**VILLAGE OF WINDSOR
BOARD RESOLUTION 2016-17**

**APPROVAL OF SITE PLAN FOR
WINDSOR ELEMENTARY SCHOOL**

RE: Windsor Elementary School - Site Plan Review Request

Project Title:
**Addition & Renovation of
Windsor Elementary School
DeForest Area School District
4352 Windsor Road, Windsor, WI 53598**

Sheet Title:
SITE UTILITY PLAN (NORTH)
 Sheet Number:
C5.1

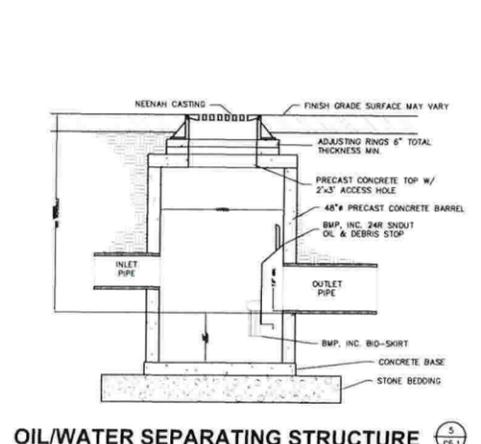
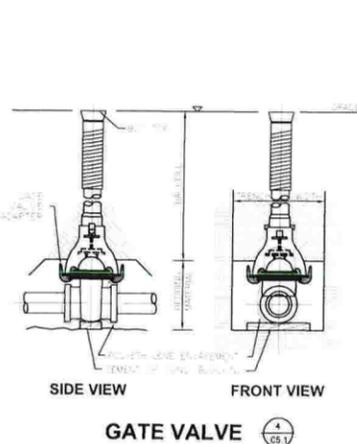
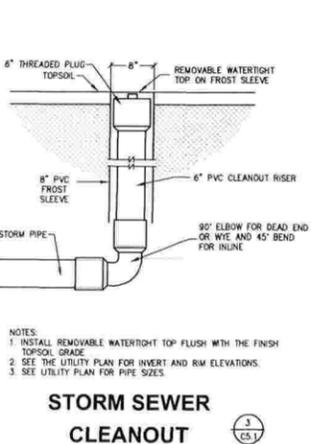
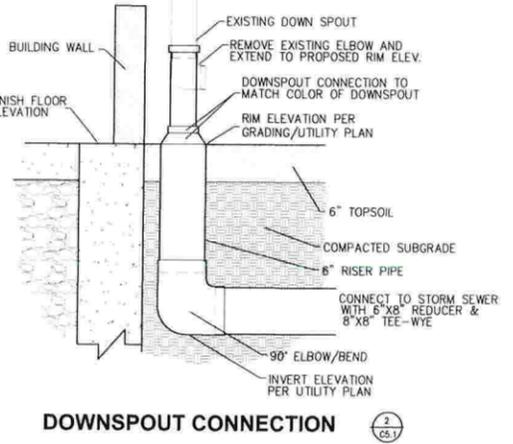
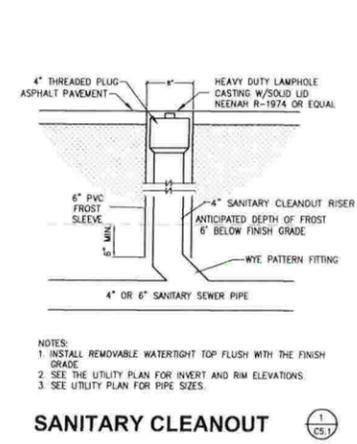
3. The Site Utility Plan does not show any utility easements on the property as required, although a number of utilities (as shown) run the length of the west property line.

Sheet Title:
 LANDSCAPE PLAN
Sheet Number:
 C6.0

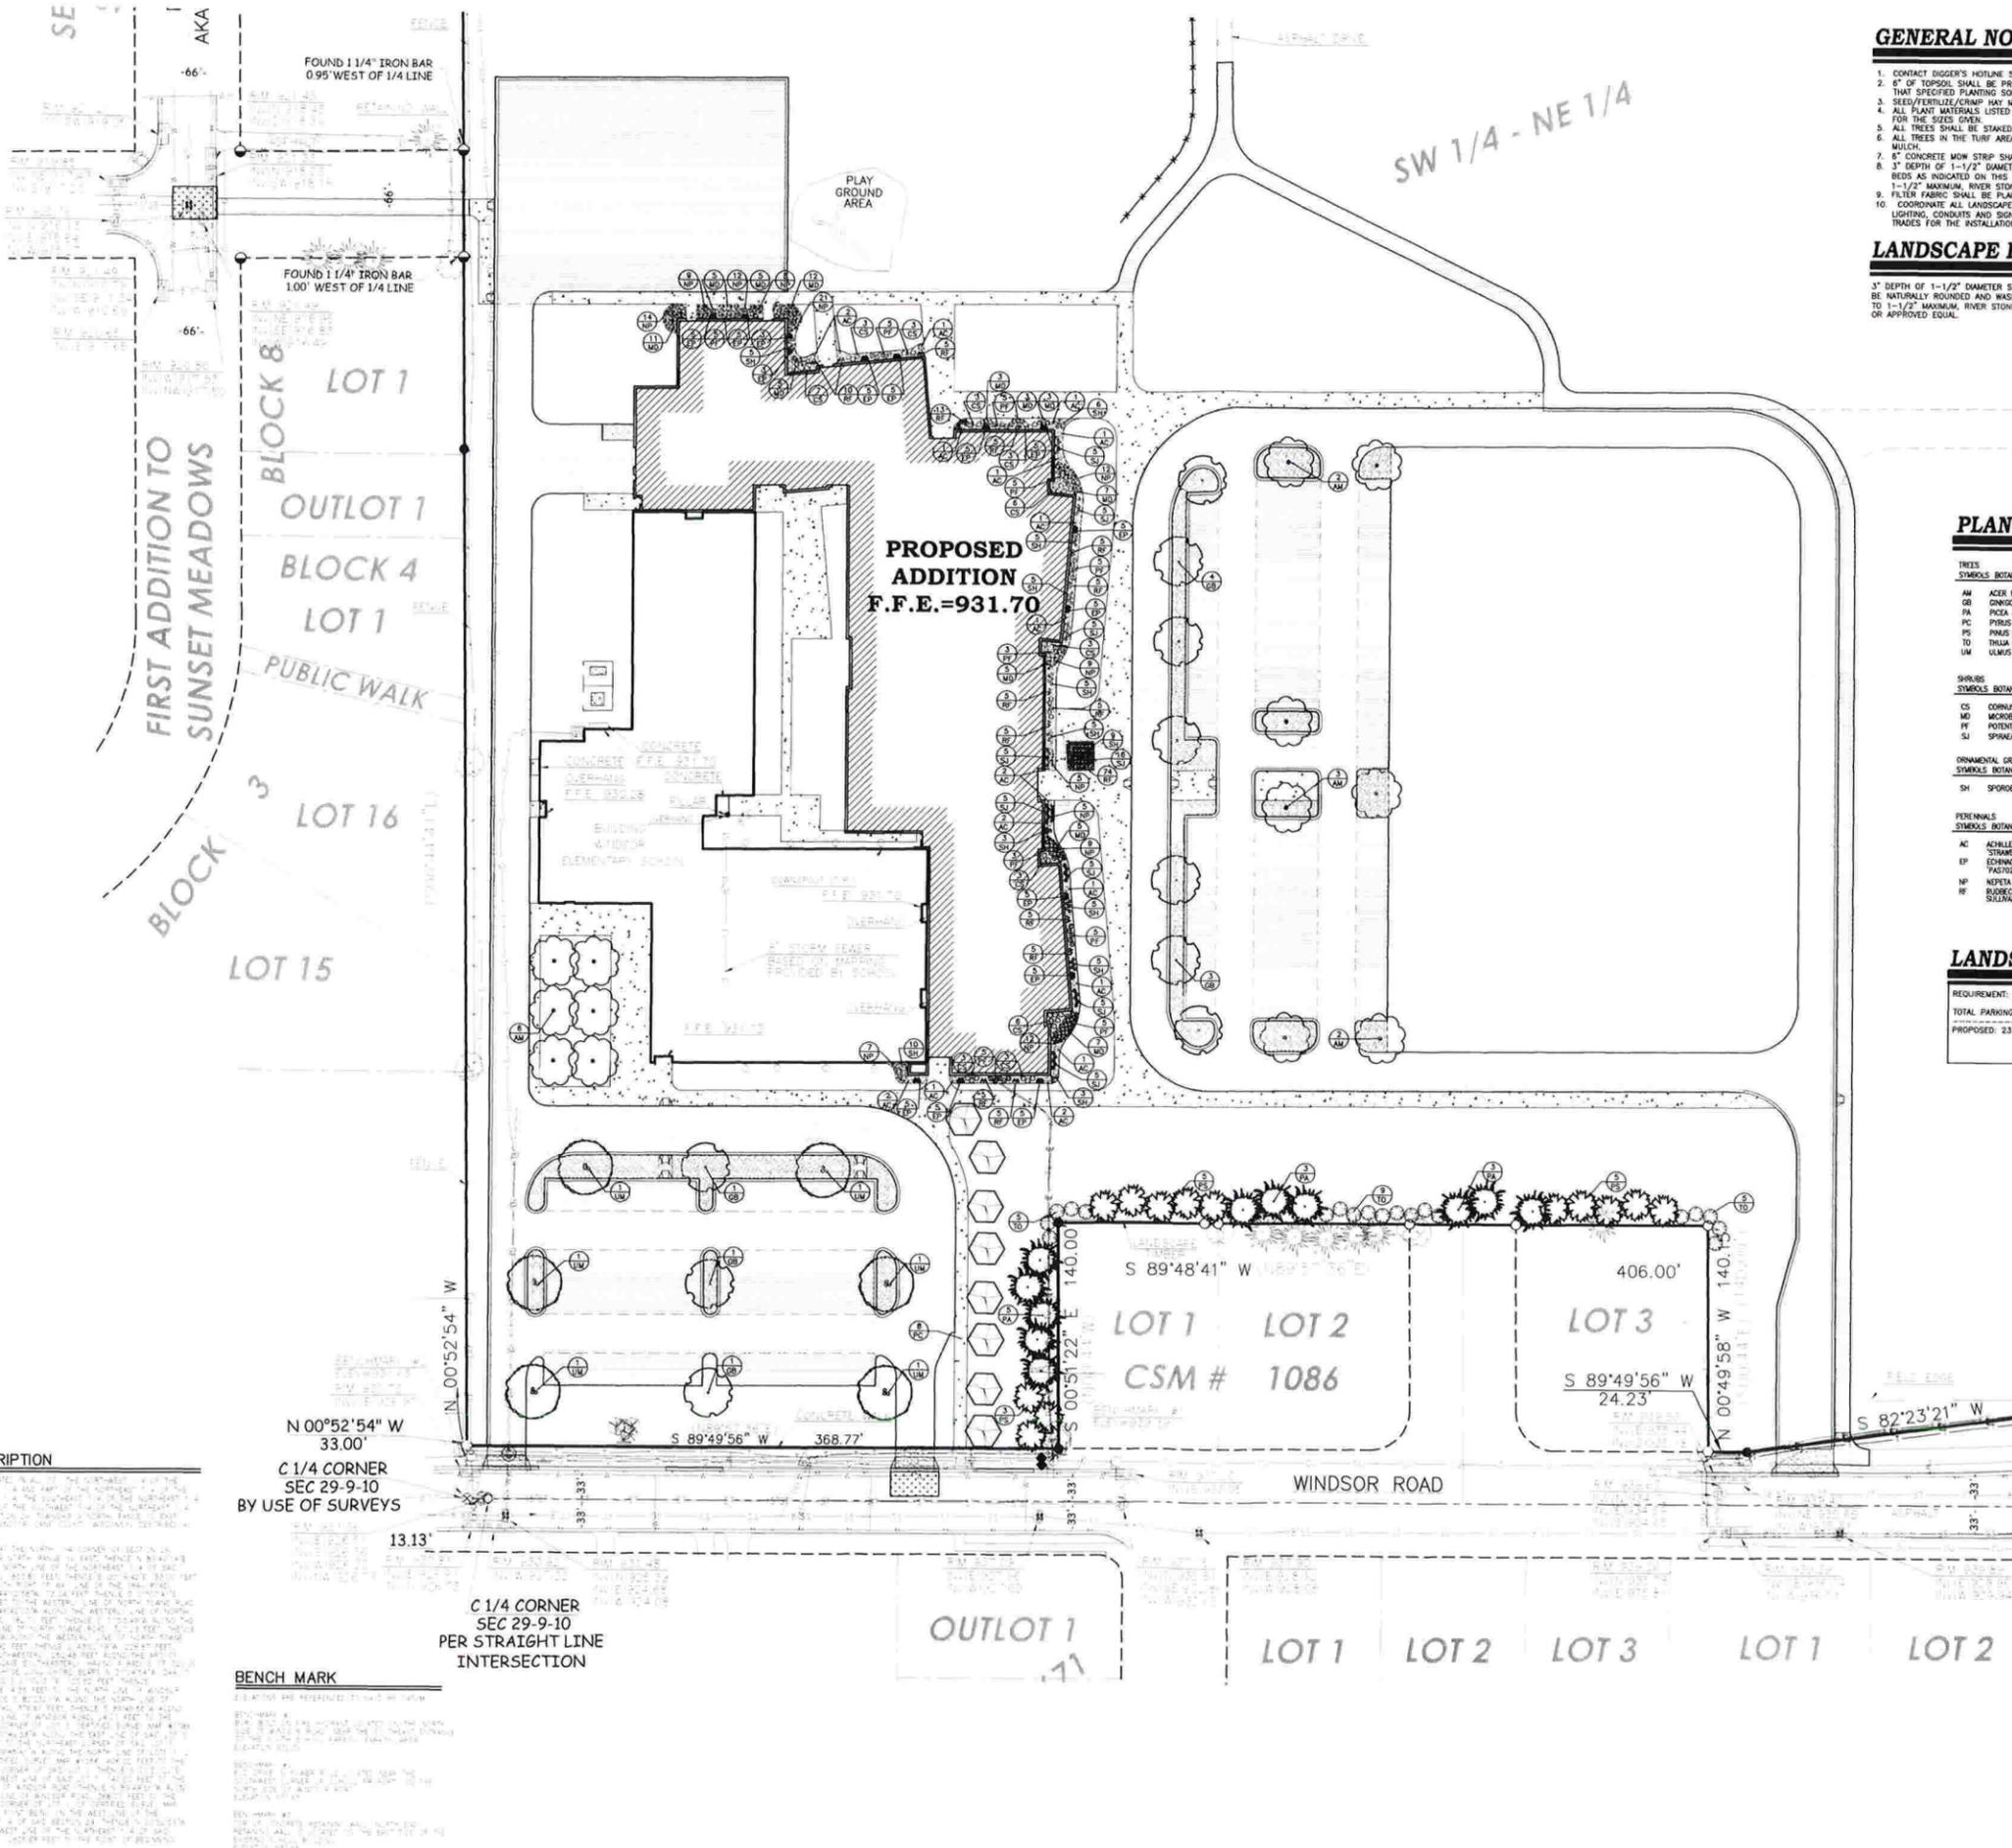
4. The Village of Windsor Site Plan Review Ordinance requires landscape buffers to be provided around parking perimeters adjacent to public rights-of-way, interior areas and immediate perimeters to the parking areas, and perimeters of lots adjacent to other property. The Site Plan Review Ordinance requires a minimum of 1 canopy tree per 10 parking spaces. Canopy trees are to be located in parking islands that are at least four feet wide or within 15 feet of the lot perimeter. A total of 211 parking spaces require 22 canopy trees. The Landscape Plan shows a total of 23 maple trees distributed throughout and along the perimeter of the two lots.
